ADDENDUM NO. 2

WASTEWATER TREATMENT PLANT EXPANSION  
KYLE, TEXAS

CONTRACT DOCUMENTS, DRAWINGS AND TECHNICAL SPECIFICATIONS

**A SECTION**  
1/4"=1'-0"

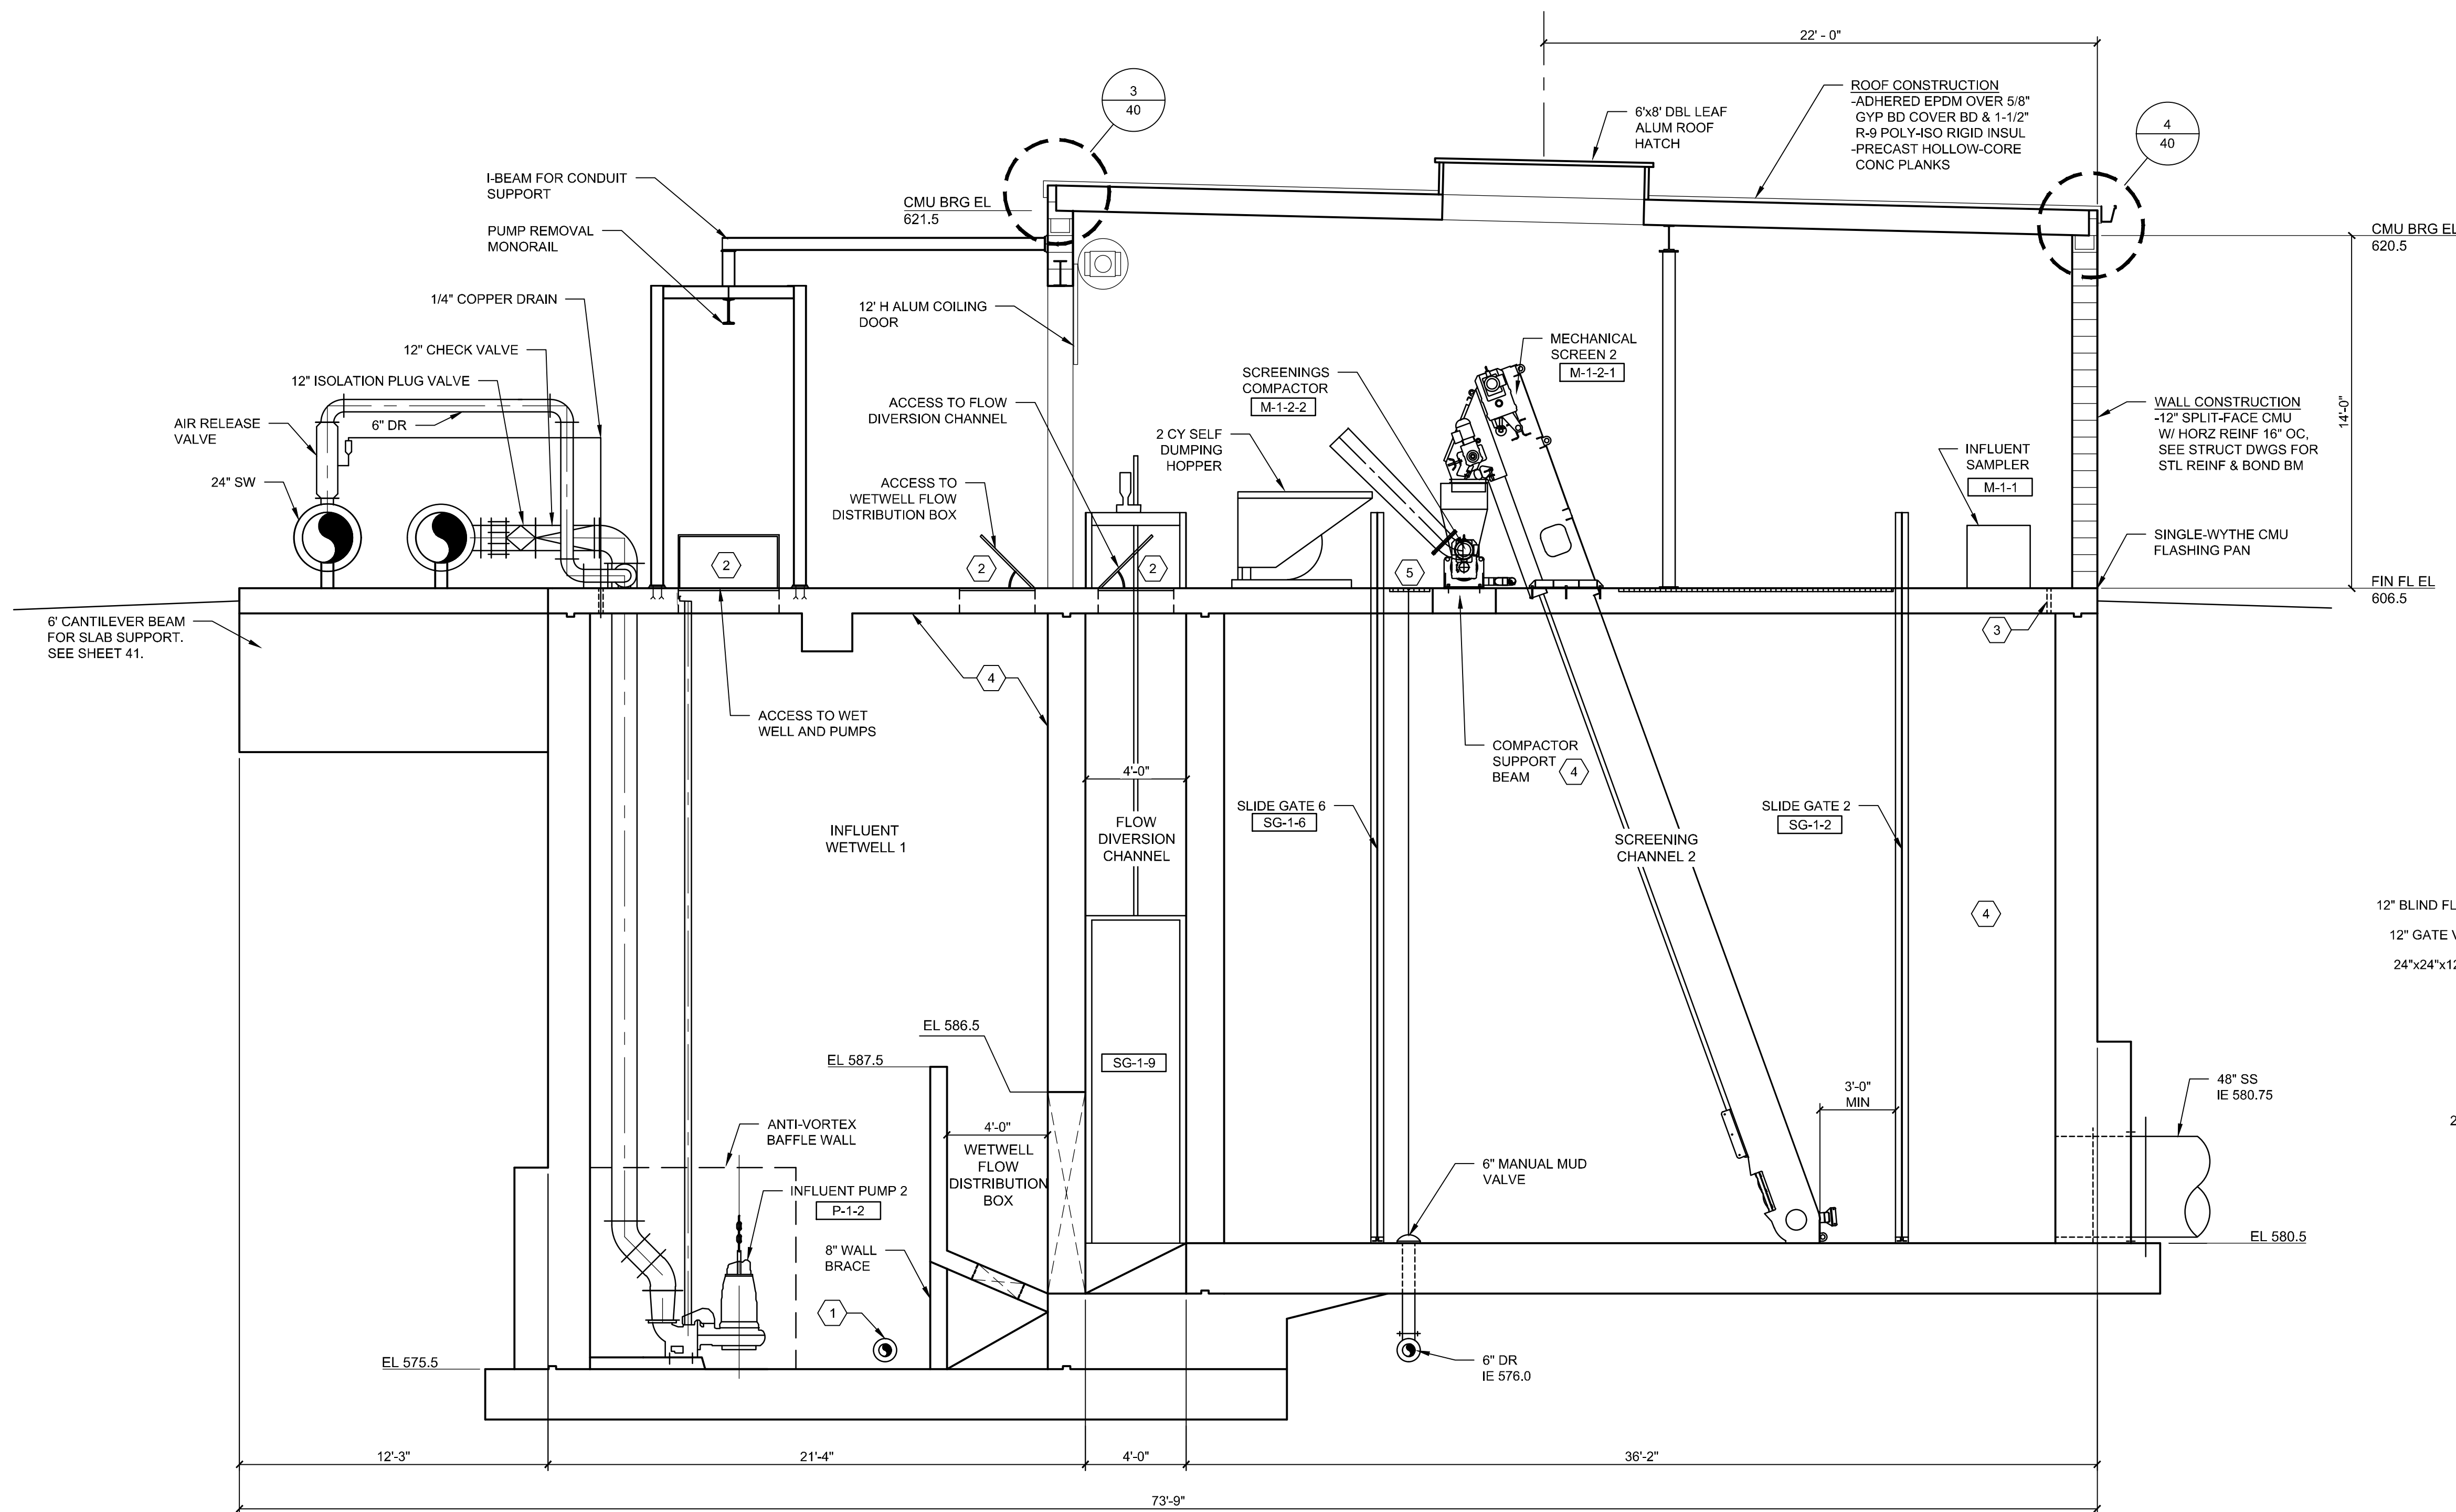
- 28      **Question:**      We see the six mud valves in the bottom of the channels in the Headworks Structure. Looking at section - D on sheet - 45, we see four of the mud valves. There are no extension stems shown in this section view. Is it up to the mud valve supplier to design the extension stem and supports for the guides? We assume that there will have to be an opening in the grating to access the top of the extension stem for the center channel with the manual bar screen. We are looking at the distance from the slide gate over to the mud valve. Projecting that distance up to the operating level, it appears that that is in the edge of the automatic bar screen and compactor support beam. Please review and clarify the configuration of the mud valve extensions. [See revised Sheets 41, 43, and 45 issued as part of this addendum.](#)

AEROBIC DIGESTERS  
 PROCESS - STRUCTURAL  
 LOWER PLAN

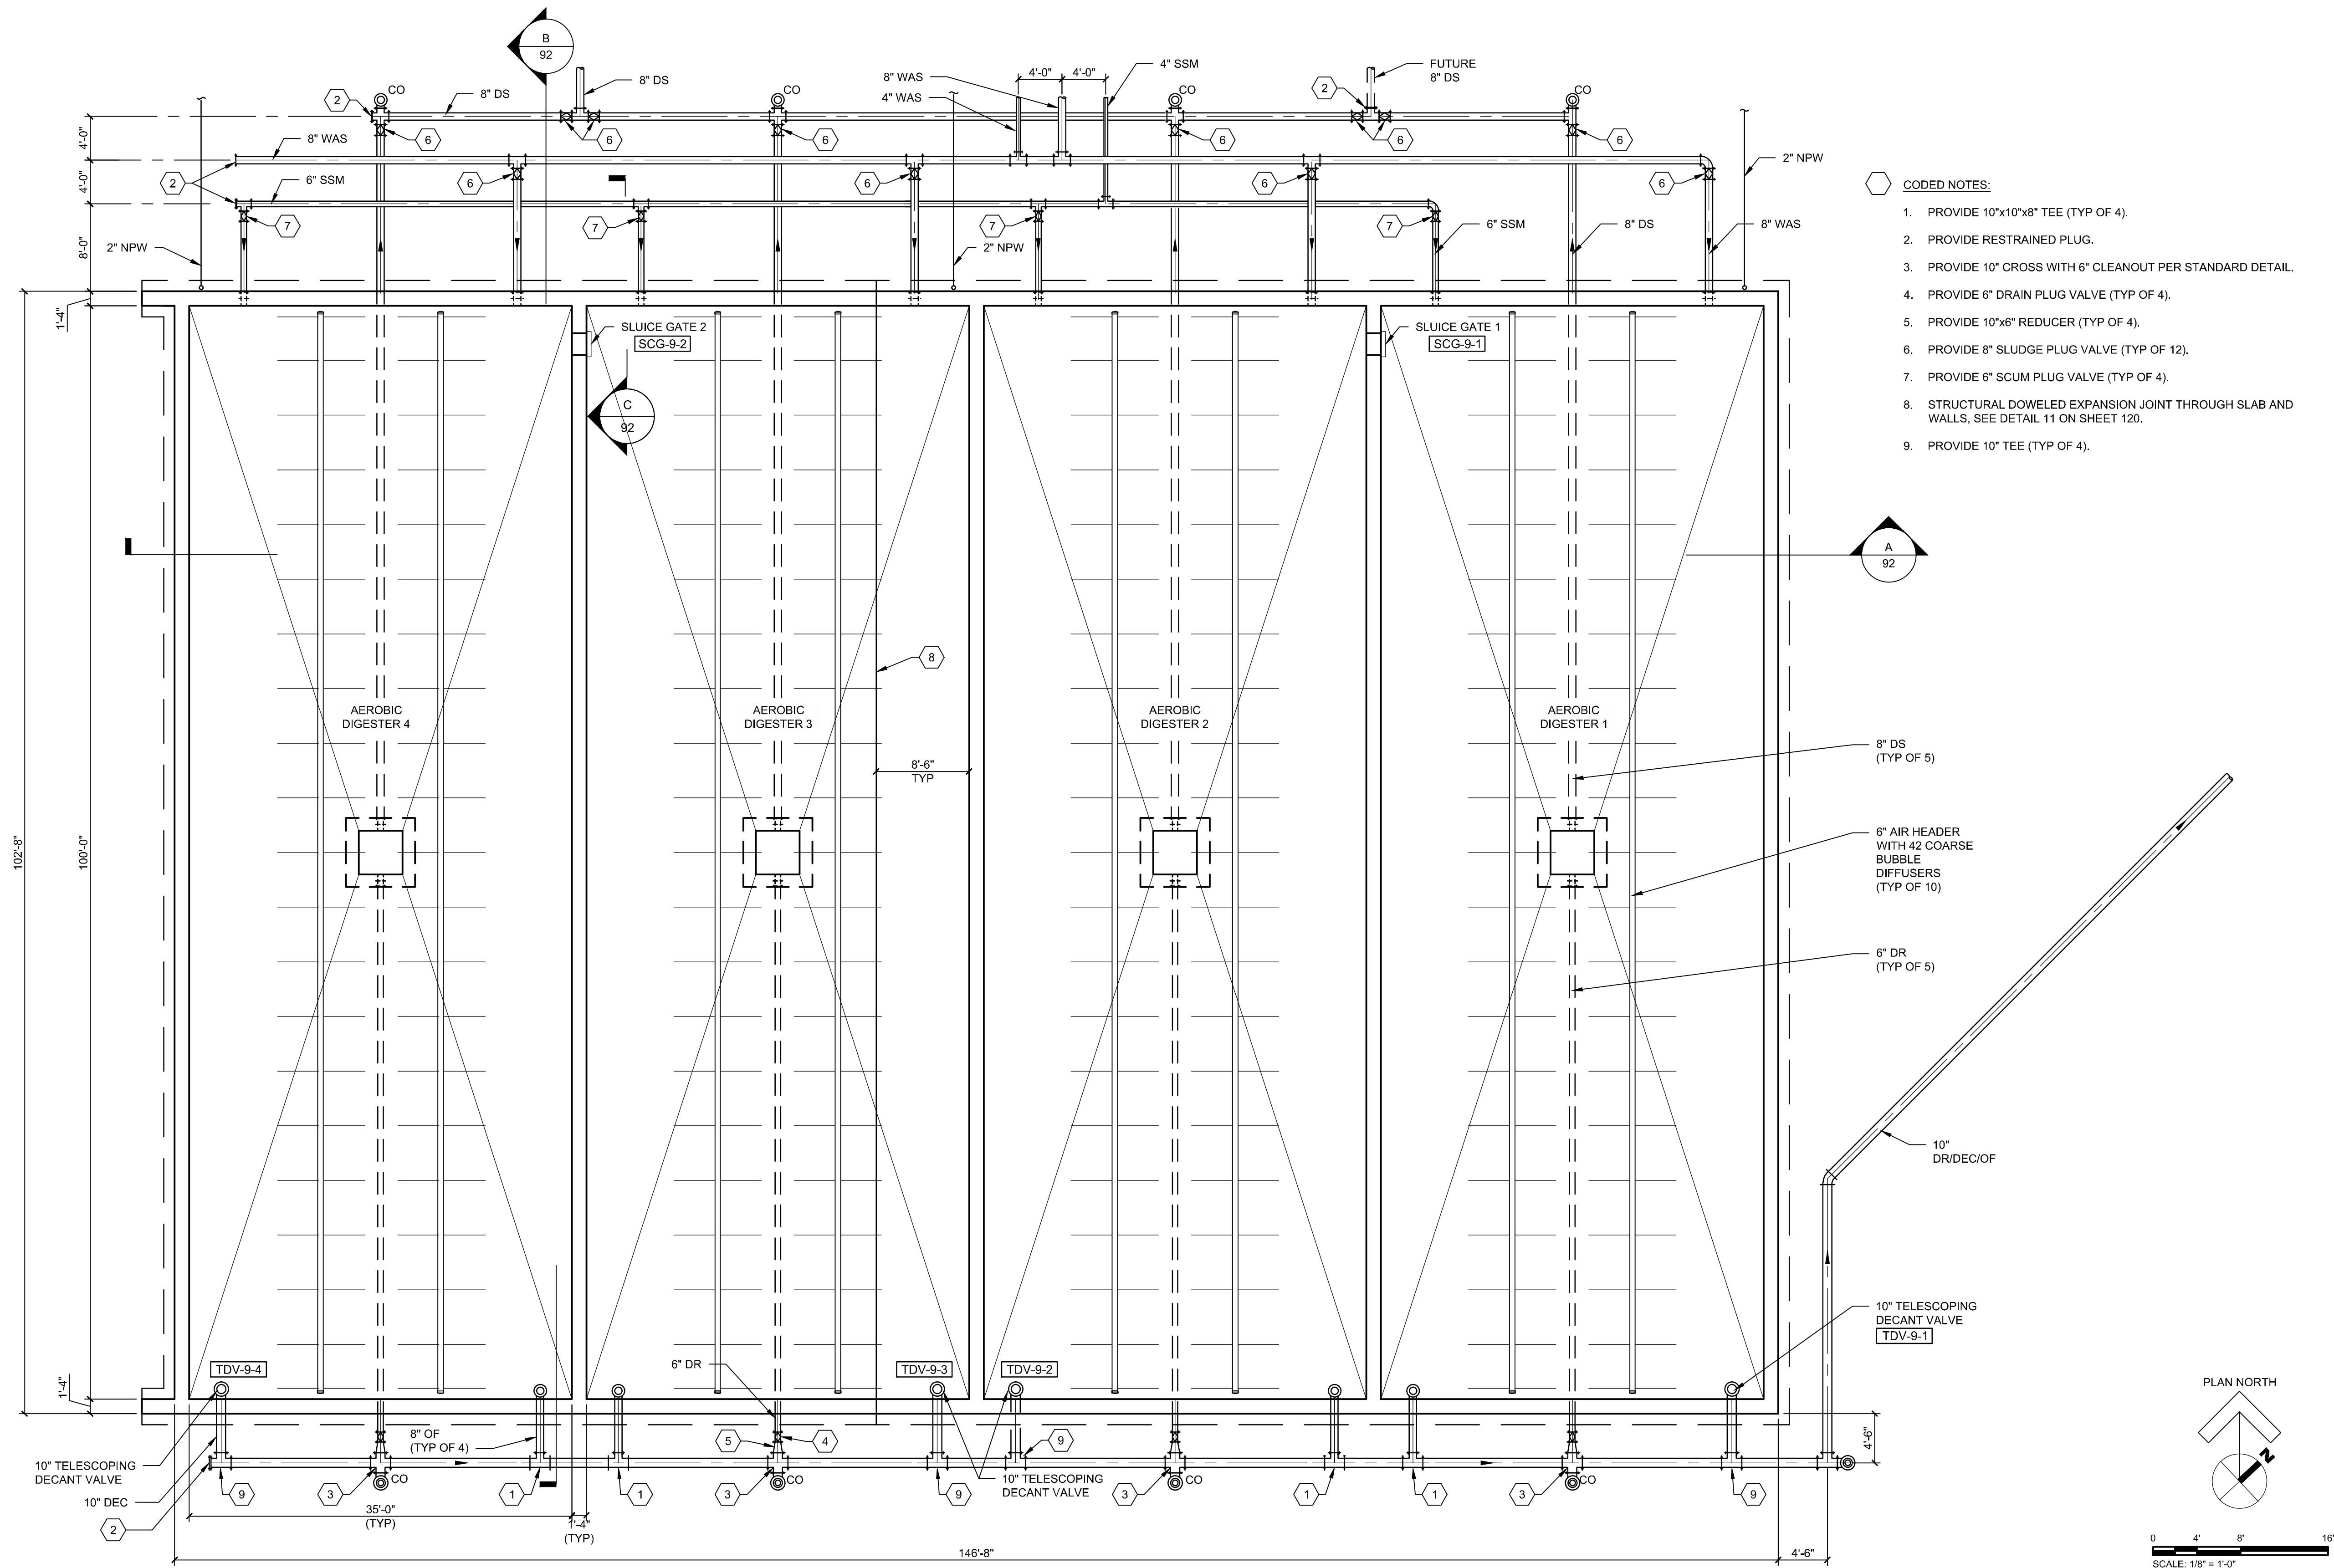
- Answer:** Delete TA designation on Sheet 128, as the Tertiary Building does not have windows.
- 115 **Question:** Looking on drawing - 90 showing the piping layout at the Aerobic Digesters, we notice a 8" SEP pipe shown coming down and connecting to the 8" WAS header pipe. This line is to the left of the 4" WAS pipe. Looking on the yard piping drawing - 26, this pipe does not appear. Please review and clarify this 8" SEP line.

- 116 **Question:** Looking on drawing - 90, we see the 8" DS line coming out from the digester structure and connecting to an 8" DS header pipe. We see two locations where the DS line extends out to the north. There are two 8" plug valves at the MJ tee fittings where the line is shown going out to the north. Then looking on the yard piping sheet - 26 of this area, we see one pipe stubbed out to the north, between Aerobic Digesters No - 3 4. The line does not appear to go anywhere. Please review and clarify the piping configuration for this DS piping and where it should extend.

- Answer:** On Sheet 90, delete the 8" SEP piping and tee interconnected with the 8" WAS header. **See revised Sheets 26 and 90, issued as part of this addendum.**

- Answer:** On Sheet 90, cap the east 8" DS line with a restrained plug. For the west 8" DS line shown on Sheet 90 and Sheet 26, extend the line to the dashed area reserved for dewatering equipment (Coded Note 5). Terminate this 8" DS line with a buried plug valve and flange 12" above grade. **See revised Sheets 26 and 90, issued as part of this addendum.**
